Iowa DAS - DOC 4JD CBC New Central Office Building

Addendum #01

Dated: April 30, 2026

ADDENDUM NUMBER ONE
To Contract Documents for:
IOWA DAS – DOC 4JD CBC NEW CENTRAL OFFICE BUILDING
SVPA Project No. 25079
Owner Project No. 9488.00

CODE PLAN AND REVIEW

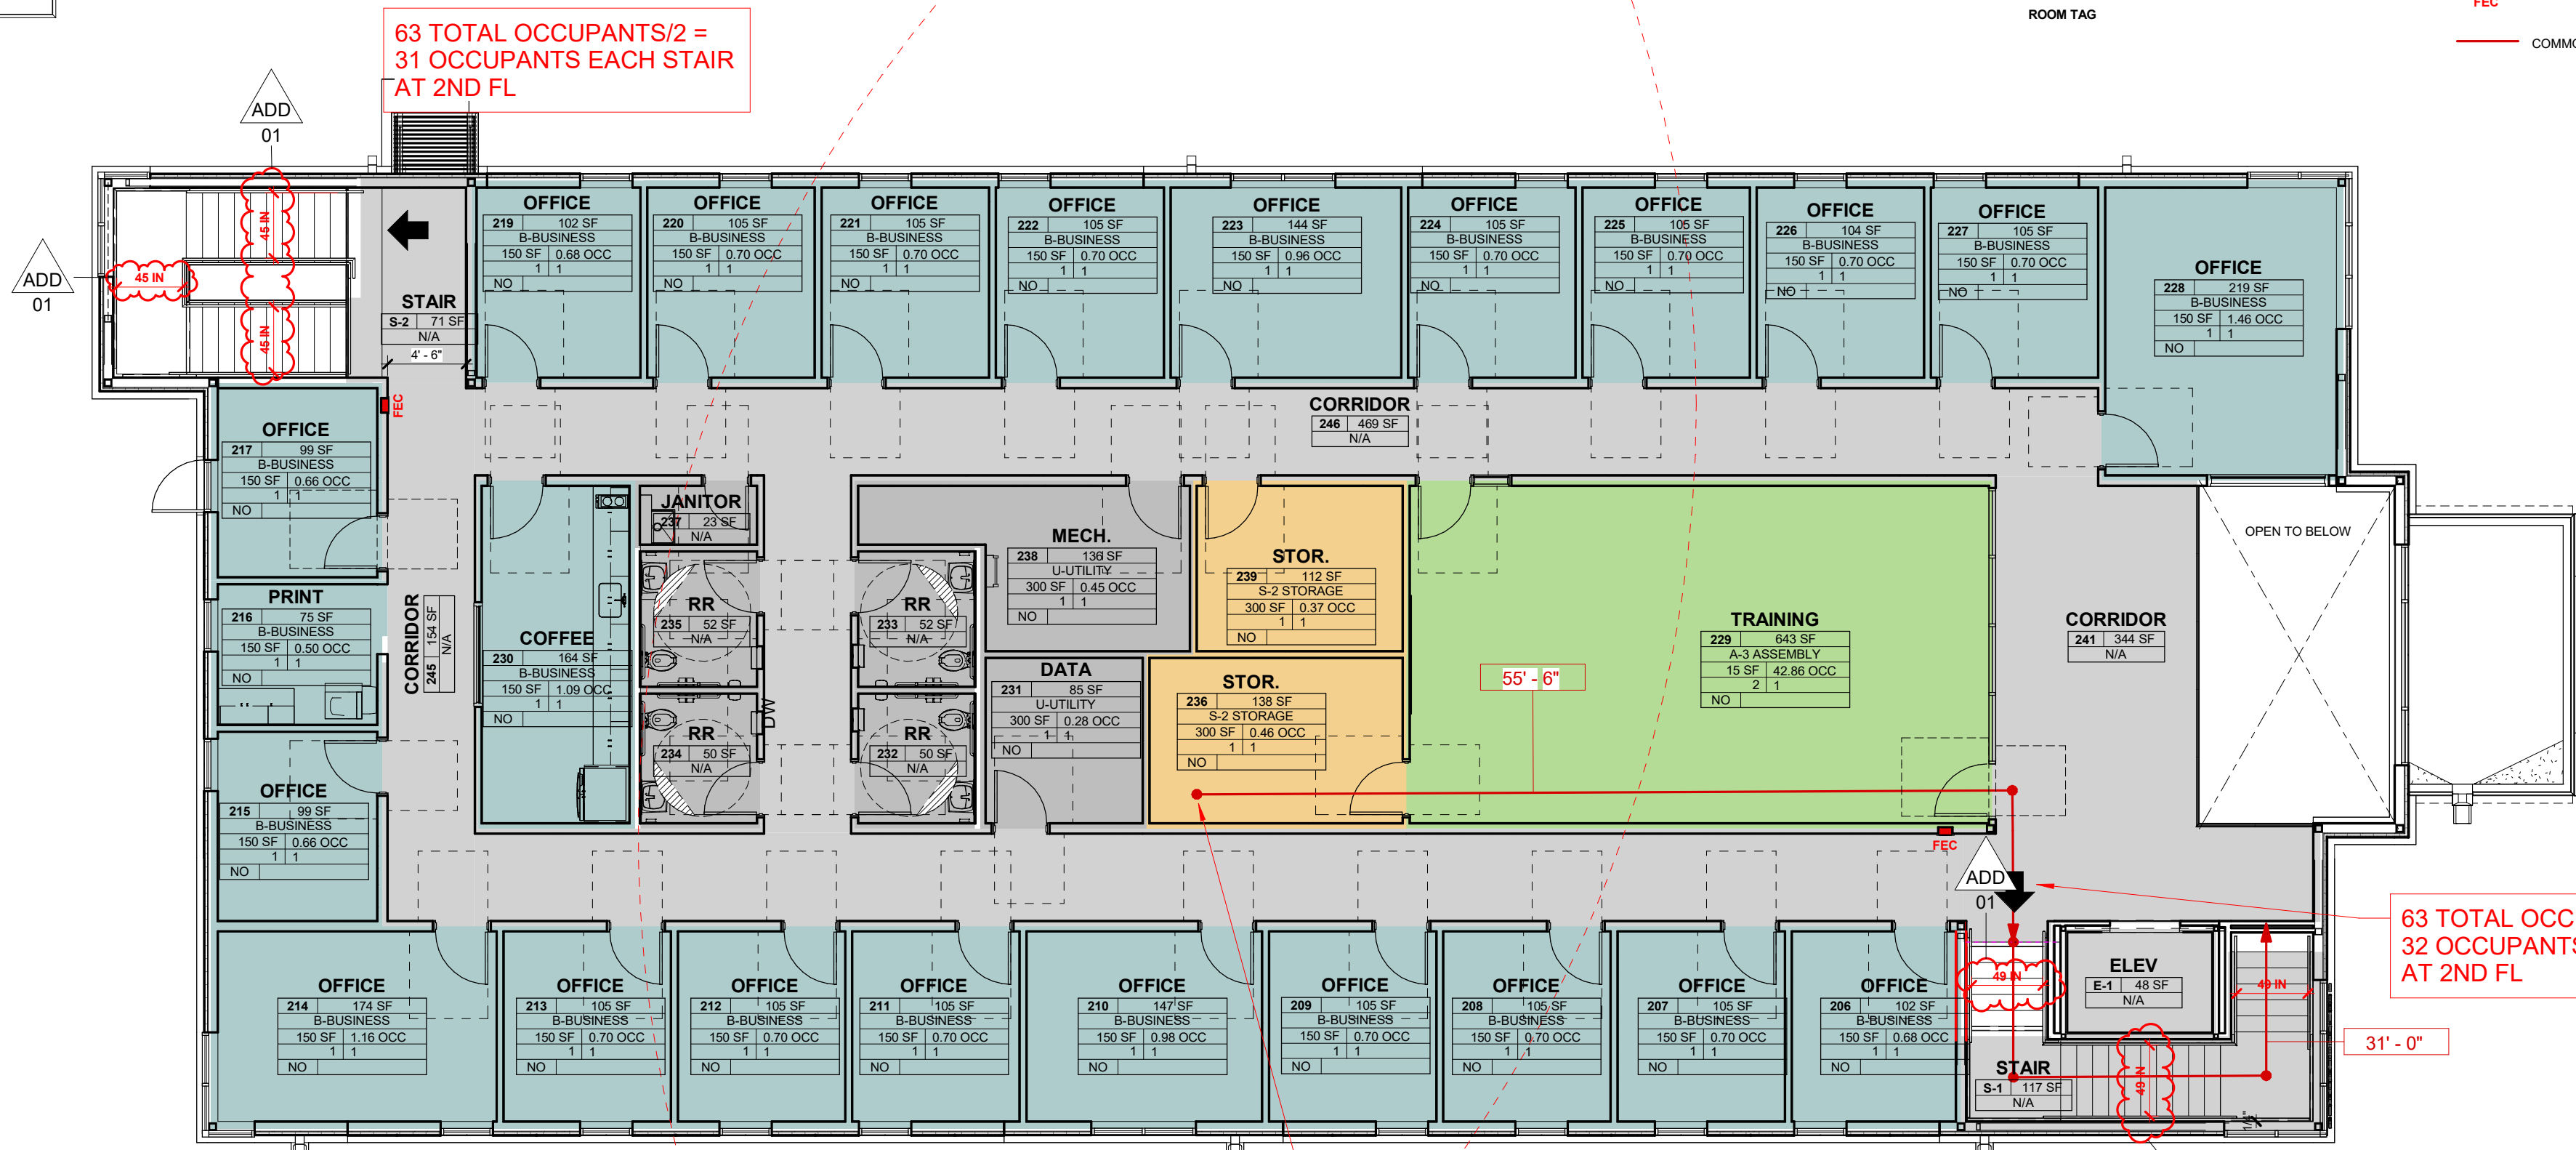
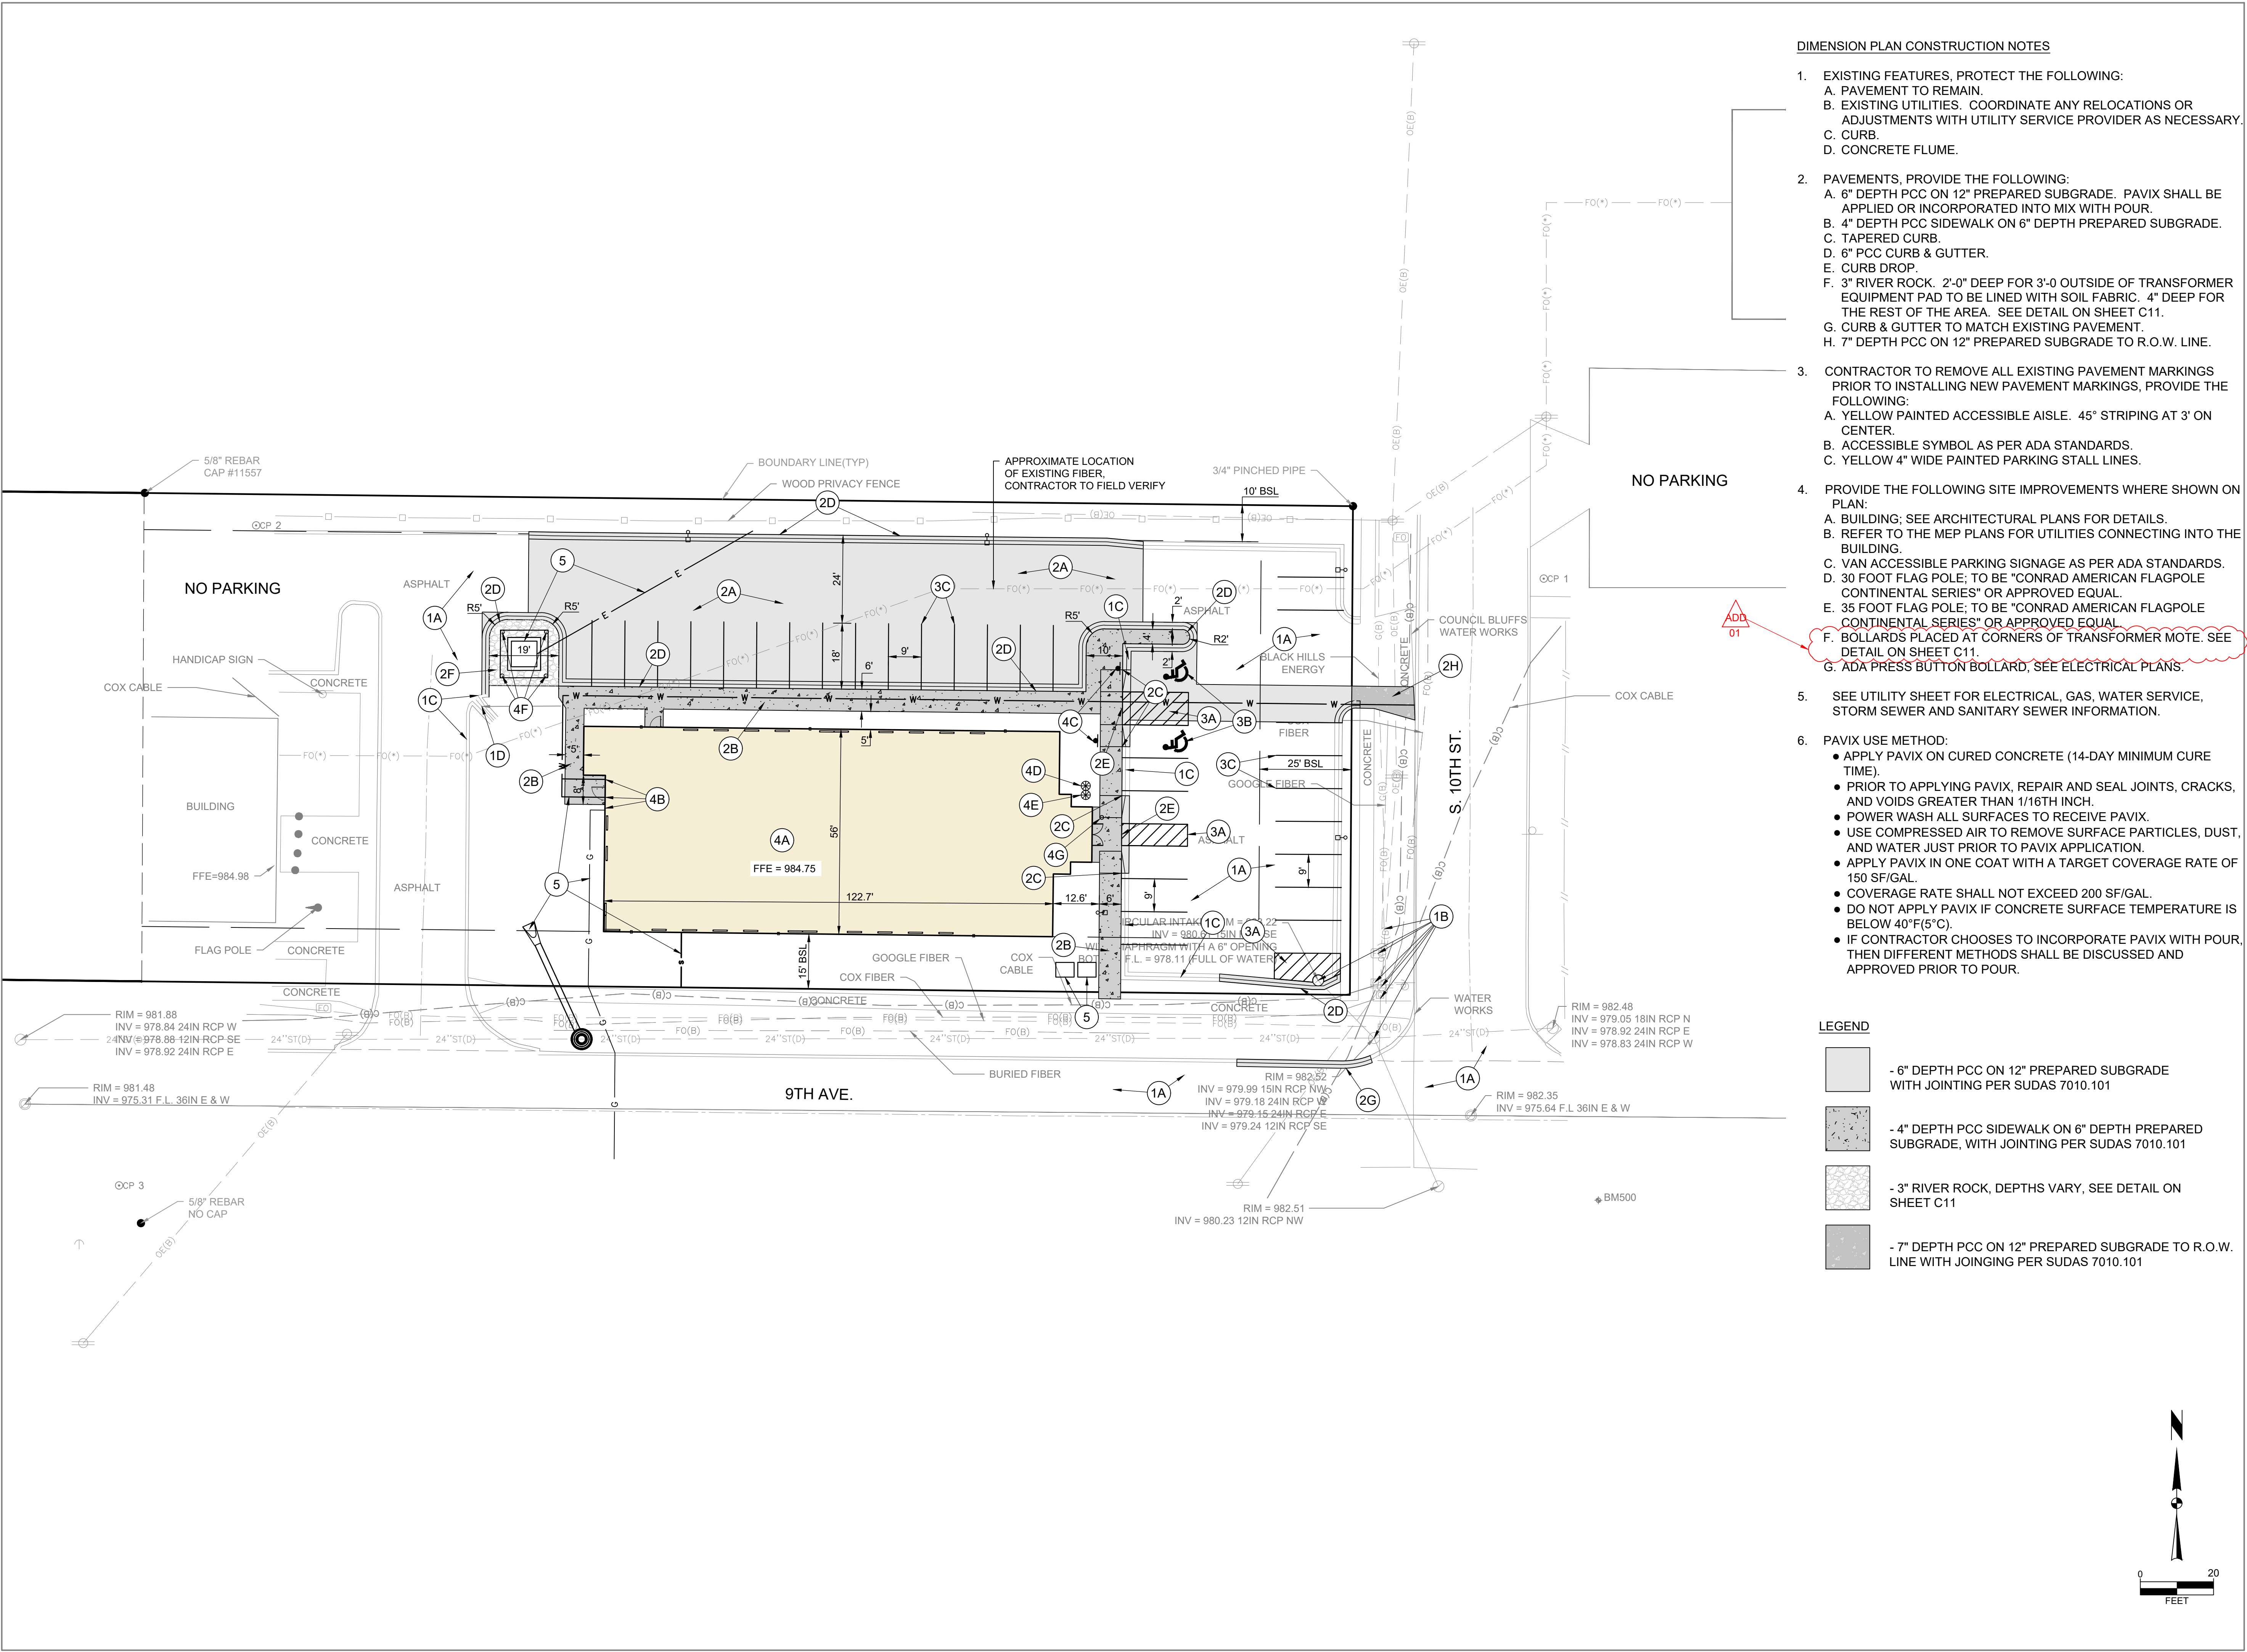
- B. See attached revised sheet G001.
2. **Sheet G002 – CODE PLAN AND REVIEW**
 - A. REVISE total building area and height.
 - B. REVISE occupancy totals.

- C. ADD dimensions at stairways.
 - D. ADD notes to code sections 1024.2 and 1028.2.
 - E. See attached revised sheet G002.
3. **Sheet C4 – DIMENSION & LAYOUT PLAN**
